RC1

This multidisciplinary study on the Loess Plateau centers on surface–groundwater interactions and fits well within the scope of the Journal-HESS. Based on extensive field observations, the manuscript investigates groundwater recharge processes within gully systems on the Loess Plateau, aiming to reframe gullies as hydrologically active recharge zones rather than merely erosional landforms. The study uses an integrated, multi-method approach — including stable isotopes, chloride concentrations, water table fluctuation (WTF) analysis, and structural equation modeling (SEM)—to examine the linkages among precipitation, surface water, and different groundwater bodies. The authors have invested substantial effort in data collection, fieldwork, and laboratory analyses. Given the increasing importance of groundwater sustainability in arid regions, the study carries clear novelty and relevance, and makes several notable contributions: (1) Reframing the hydrological role of gullies in the loess hilly region (core innovation); (2) Identifying the key mechanisms and process chain of groundwater recharge within gully systems; (3) Demonstrating the significant enhancement of groundwater rec

Fig. 2. The geographical location and sampling sites for rainfall, pond water, pore water, spring water, and fissure water in the Nianzhuang catchment.

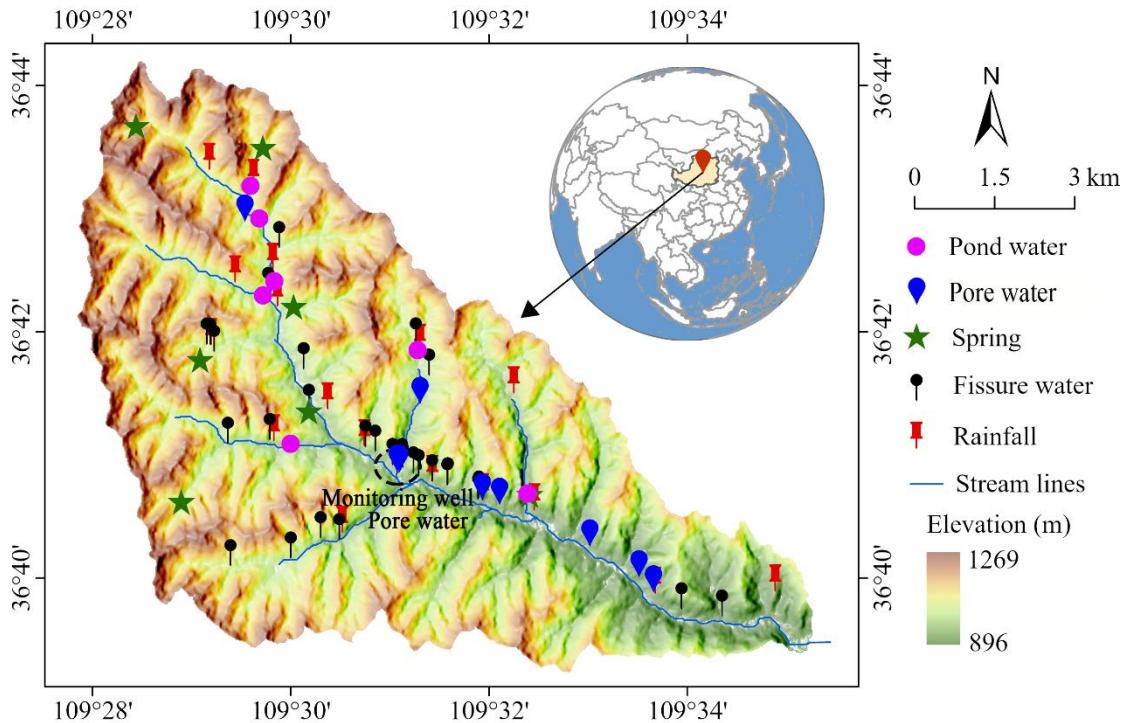
3. Line 180: How many wells in this catchment were monitored? Please show their positions in Figure 2.

Response: The monitoring network in this study includes 35 discrete sampling wells: 9 for pore water, and 26 for fissure water, aimed at characterizing the spatial variability of groundwater hydrochemistry and isotopic signatures. All sampling locations are clearly marked in Fig. 2 of the

original manuscript. Additionally, one continuous pore water table monitoring well is installed in the middle reaches of the catchment to quantify groundwater table fluctuations and estimate recharge rates. In response to your comment, we have updated Fig. 2 to include the location of this monitoring well. The specific revisions are detailed below.

Fig. 3. Hydrogeologic cross-section of the study area. Cross-section along Line 1 (Northwest-Southeast) (a); cross-section along Line 2 (Southwest-Northeast) (b); location map of Line 1 and Line 2 within the study area (c).

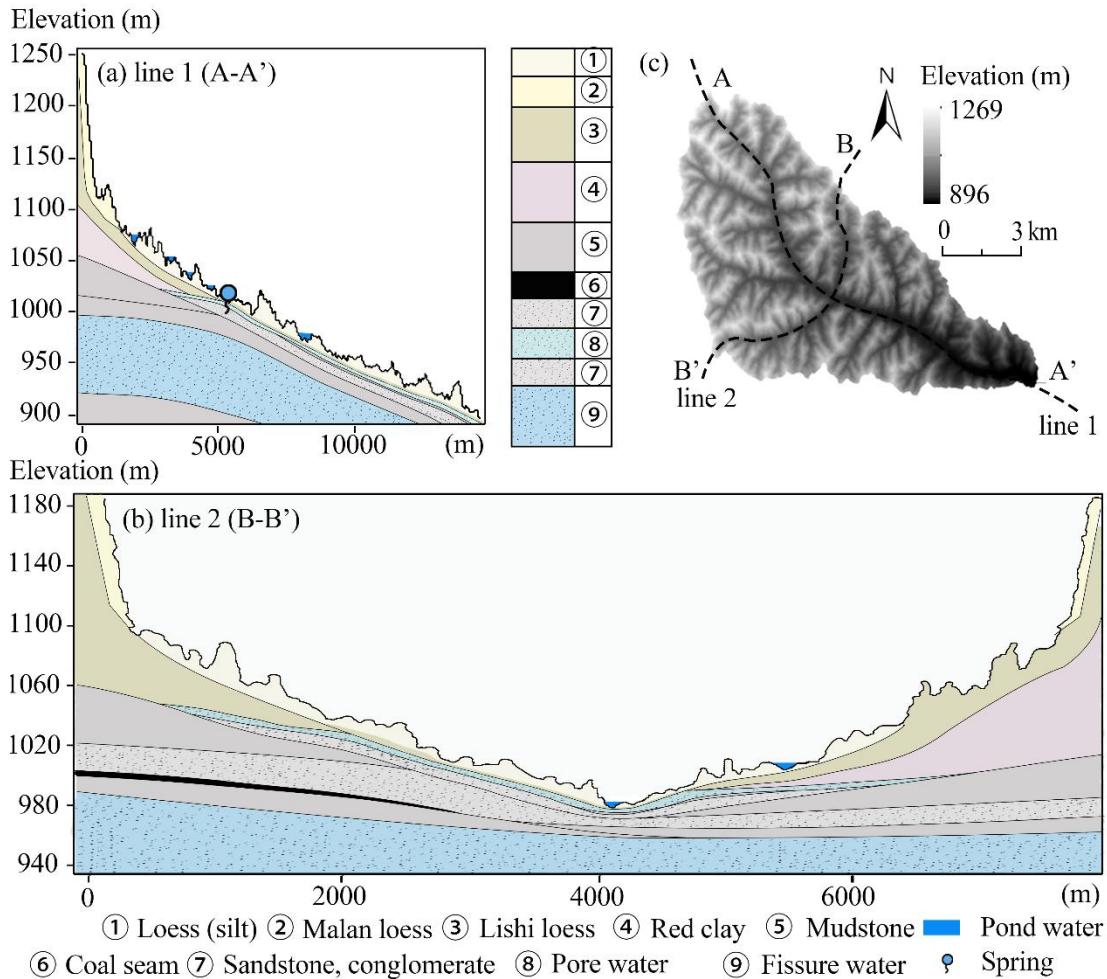
1. Fig. 3a and 3c lack units on the x-axis. Additionally, the directions of profiles Line1 and Line2 should be clearly indicated in Fig. 3b.

Response: We appreciate your comment and have made the necessary revisions. The units on the x-axis have been added to both Fig. 3a and 3c. Additionally, the directions of the profiles Line1 and Line2 have been clearly indicated in Fig. 3b. The specific additions are as follows:

Fig. 9. Temporal dynamics of pore water table depth, temperature, precipitation, and recharge in the gully region of the Loess Plateau.

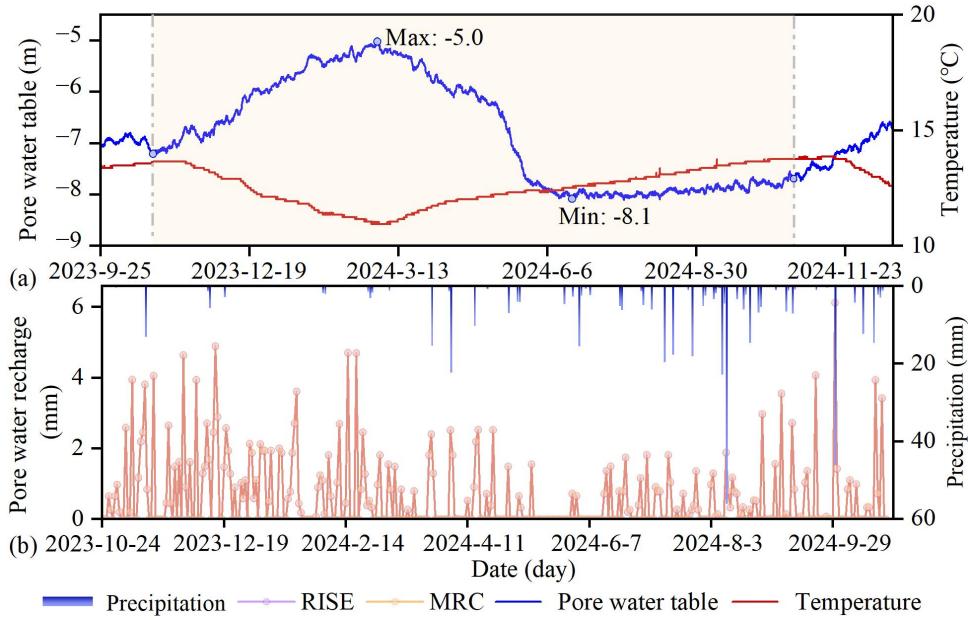
2. The terms 'Pore water table' and 'Porous water table' in Fig. 9a should be standardized for consistency.

Response: We have addressed this comment by standardizing the terminology in Fig. 9a, consistently using 'Pore water table' throughout. Additionally, we have reviewed the entire manuscript and made similar revisions to ensure consistency across all related expressions. The

Fig. 9. Temporal dynamics of pore water table depth, temperature, precipitation, and recharge in the gully region of the Loess Plateau.

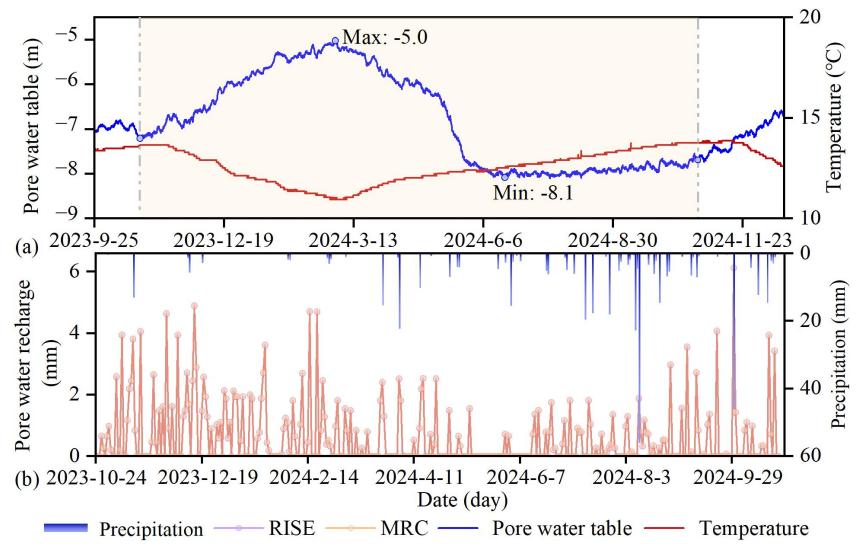
3. In Fig. 9b, the overlap of 'pore water recharge' and 'precipitation' affects the visibility of the recharge results. It is recommended to display precipitation separately or on the upper axis of the figure.

Response: In the original manuscript, we placed the precipitation and pore water recharge data on the same axis to better illustrate their synchronous relationship, which led to some visual overlap. Following your comment, we have moved the precipitation data to the upper axis of Fig. 9b, ensuring that the visibility of the recharge results is not obstructed. The specific revision is as follows:
